Motions to introduce to the GTC.

Girdwood Trails Master Plan
Trail Committee Submission

Draft Trails Master Plan Suggested Edits

New Danich Connection Trail

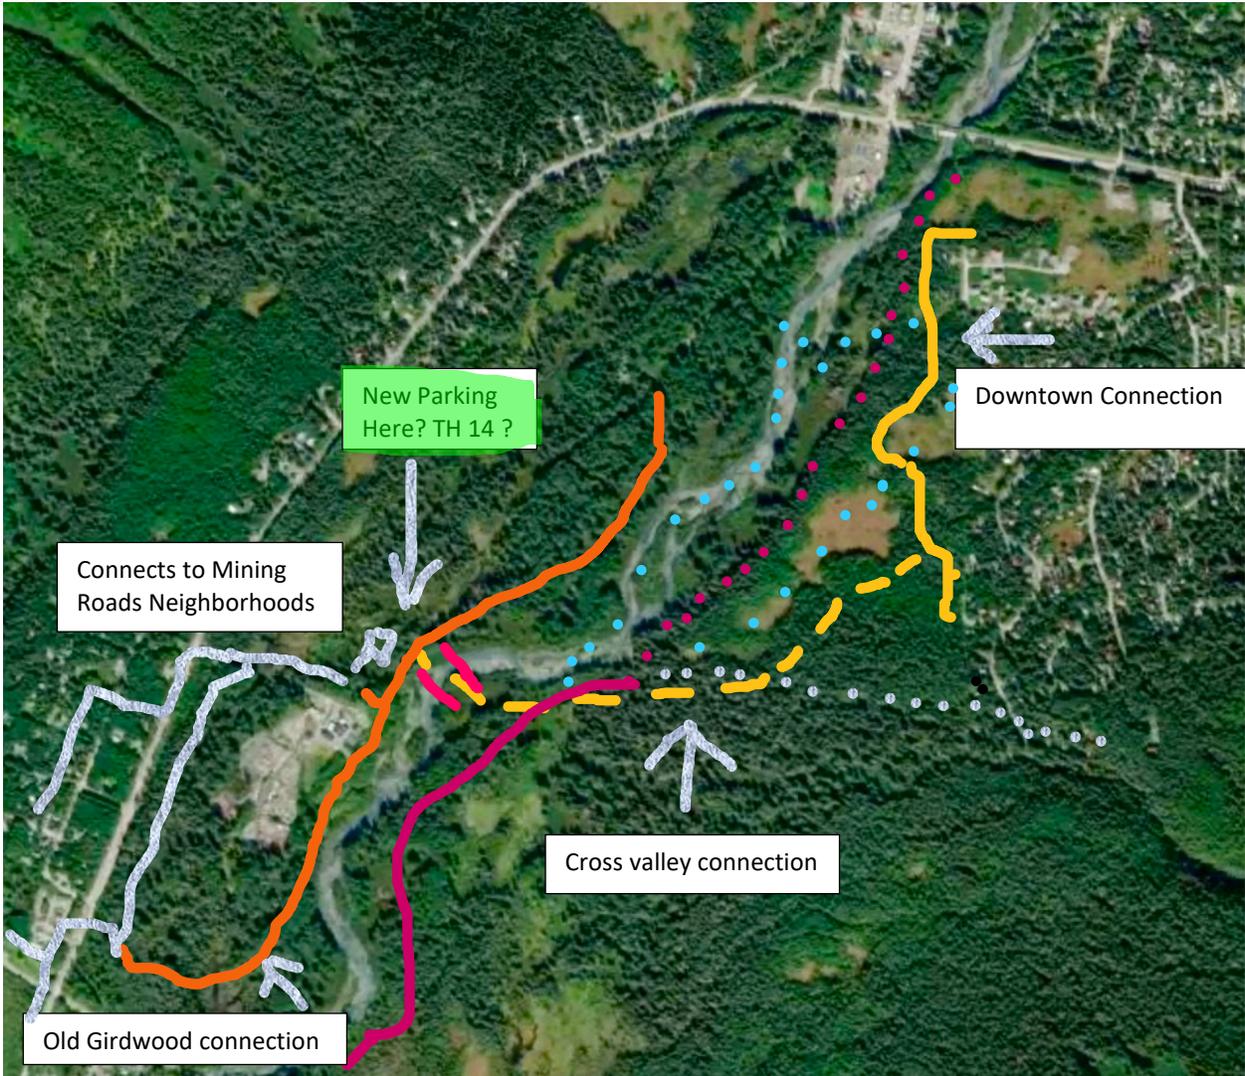
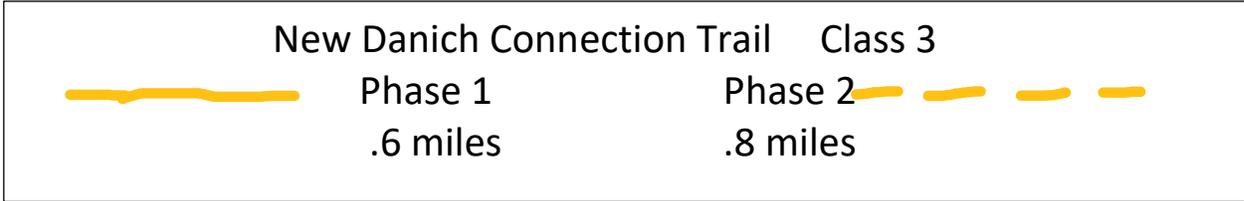
- Motion 1 Add to the draft plan a new class 3 trail traversing parcel 6-036 and other nearby lands generally following the route that is indicated on the attached map.

- Motion 2 Add to the draft plan a new site to locate bridge 1. Remove from the draft plan the old location of bridge 1. Select the new location of bridge 1 to correspond with the southern termination of the trail described in motion 1.

- Motion 3 Add new trailhead parking #14 near the southern termination of the trail described in motion #1.

The Upper Danich Trail is drawn as a trail on the map but very little trail really exists. Trails here are intermittent, are class 1 at best and do not exist at all for most of the route. Should we remove it from the draft map, mark it as a route only, or should we mark a sustainable trail alignment on the ground?

Relocate Bridge #1

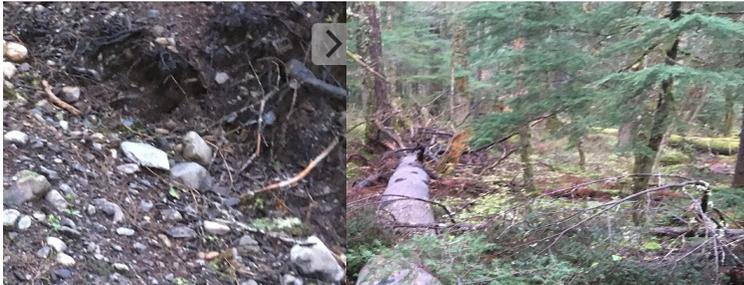
Add: Parking
Trailhead 14

The area north of the Transfer Site is level with widely spaced cottonwood trees. This is likely one of the cheapest places to build parking. Signs on the Highway can direct Anchorage people to park there for middle valley trail use. This is a logical location for a major trailhead that can serve local residents and **Anchorage** visitors.

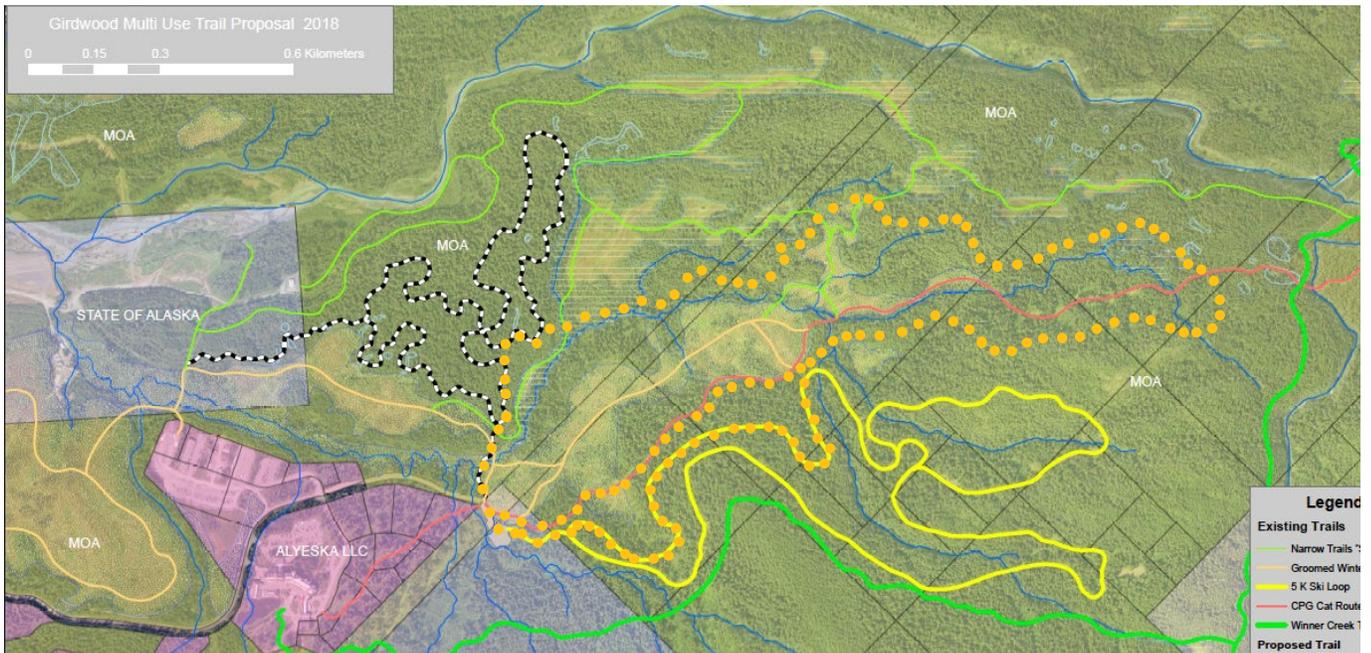
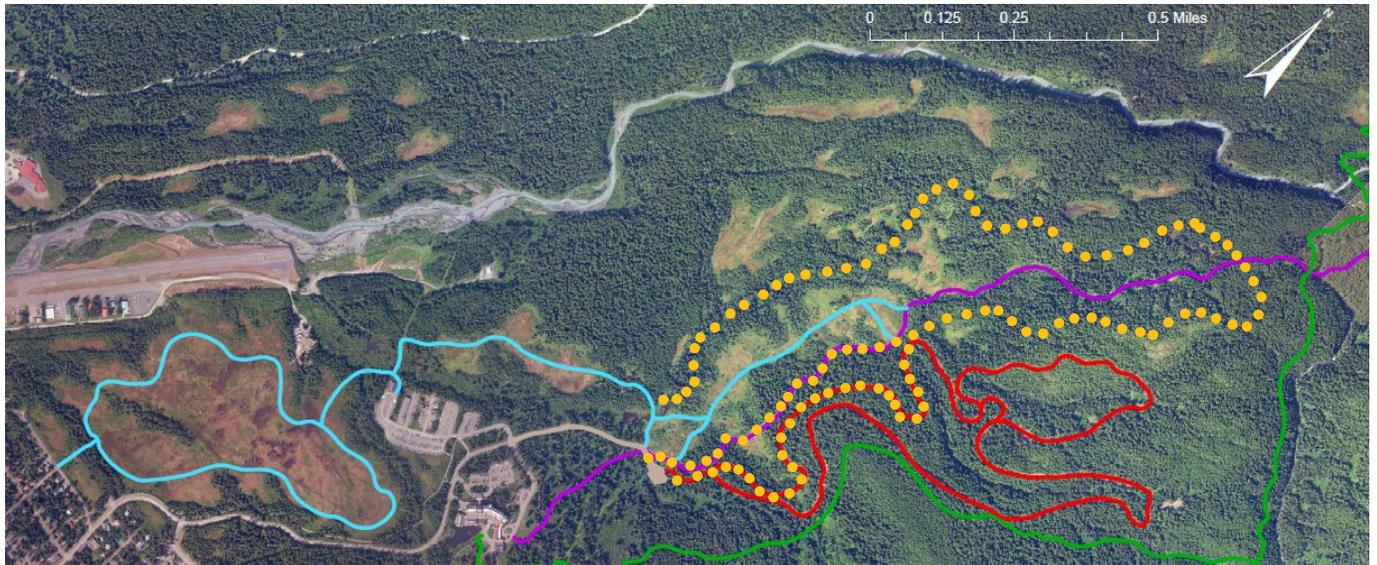
2) **I move to connect the Upper Joe Danich trail with the Virgin Creek Trail.** This would be in response to the community's comments and help alleviate Timberline traffic and over-crowded trailheads from the Timberline and Virgin Creek neighborhoods. A sustainable trail loop within this Timberline / Virgin Creek area could provide a safe connection to Hightower Town Square for the neighborhood, and from the Town Square parking to the Falls. Historically, as a community grows, more trails are created for both transportation and recreation. When these needs are not met, social trails start to pop up and the well-maintained trails in place are overloaded . This is where we are in Girdwood. The majority of our trails were not designed for recreation, but are the remnants of old mining and logging roads. It would be ideal to keep the Lower Danich and Wagon Trail primitive, and to connect the Upper Danich and Upper Virgin Creek Trail up to the Falls.

3) **I move that we add back an Upper Valley Connector from the Forest Loop to the CPG CAT Track near the CAT Track Bridge.** While the exact area of the connector trail can be discussed in the future, showing a Class 4 year-round looped trail system is congruent with the community survey results and Girdwood Master Plan comments. The trail originally included in the plan was removed because people commented the space was crowded. Yet, if you look at the summer map the GTC created (shown below), no summer trails exist in this area. This area has been repeatedly zoned and defined as Open Space and Recreation Zone. In 2006, HLB commissioned a trail feasibility study to determine where to add 20 Kilometers of multi-use trails to this area. I agree that the primitive trails should remain primitive, but I disagree with this proposed primitive area covering all of the uplands of the Girdwood valley west of the CAT track, thus prohibiting a future multi-use trail system development that includes summer or winter bike travel.

Page 42: Trailhead 4

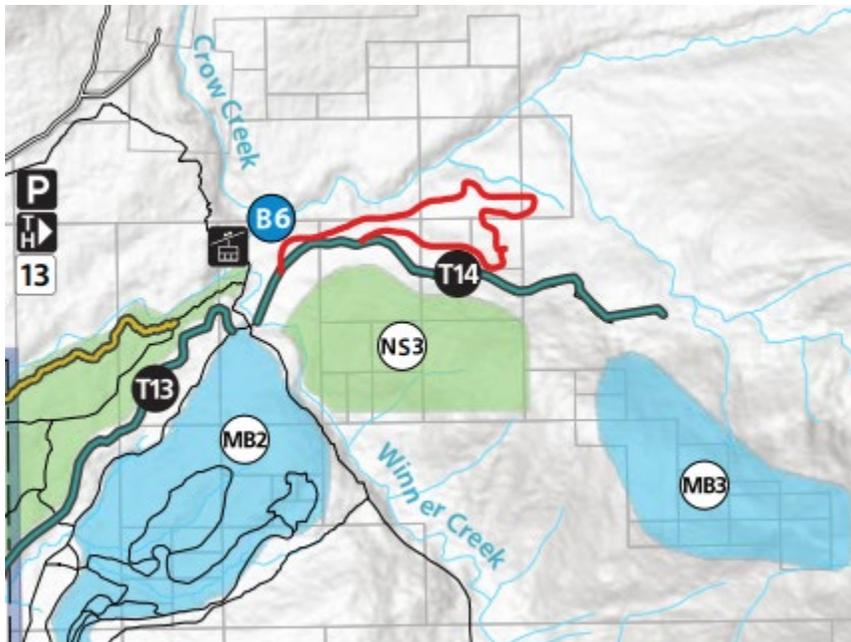
Proposed change: Title - Virgin Creek Falls Trailhead
(not access study)

Keep bullet points 1,2,3

Add bullet point 4:

Upon completion of the above mentioned study, and a review of the suggested alternatives by GTC there will be implementation of the preferred option.
